## 4.0 Clarifications

#### **4.1 Clarification on the content of this submission**

Fig. 2.7 - Consented View - Along Charlotte Street

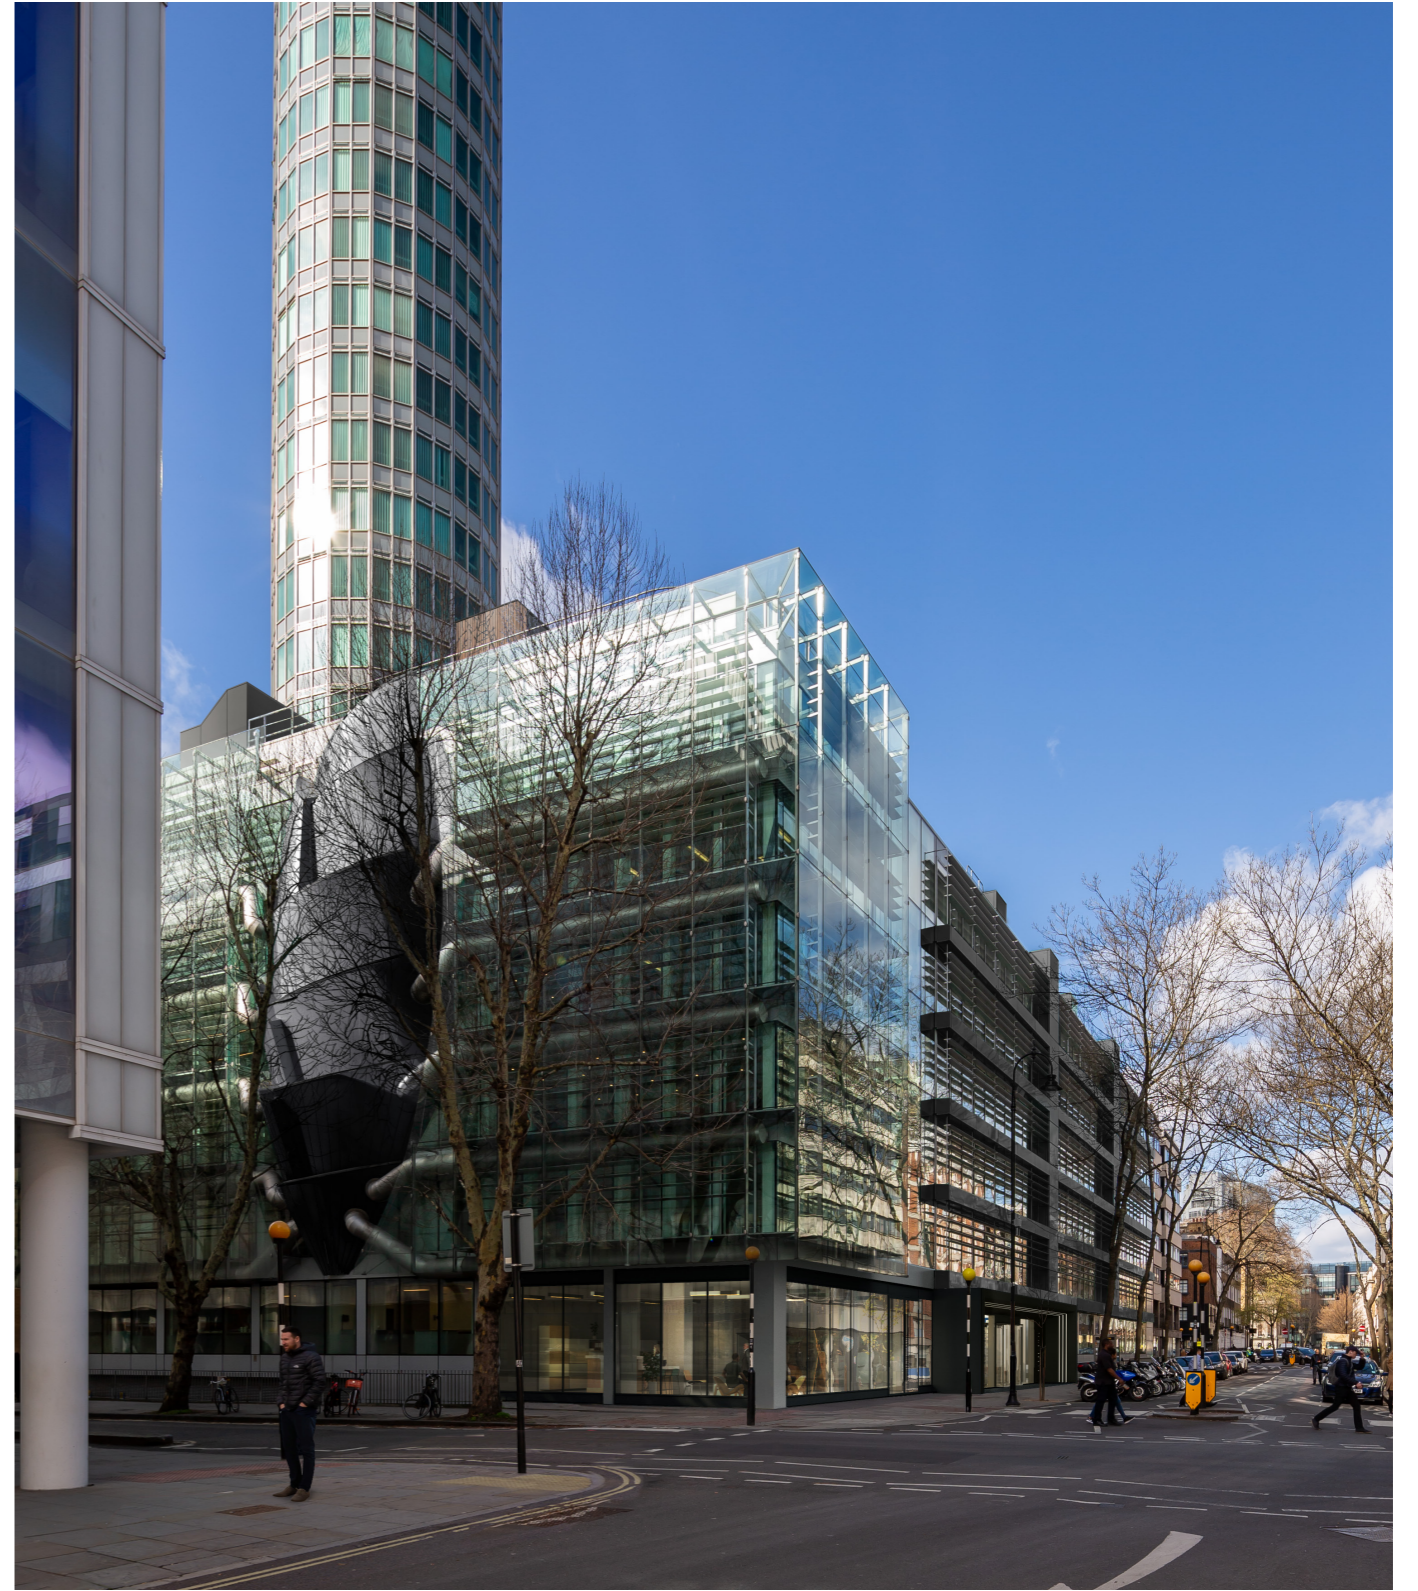
There is a minor inconsistency between the consented and proposed elevations. This minor inconsistency is due to a lack of detailed survey information available at the time of drawing the existing and consented elevations. During the design development, a tri-dimensional survey was commissioned by the client. Once we were provided with this detailed survey information, it was possible to more accurately complete the facade drawings and subsequent design changes illustrated in this document and the previously consented NMA.
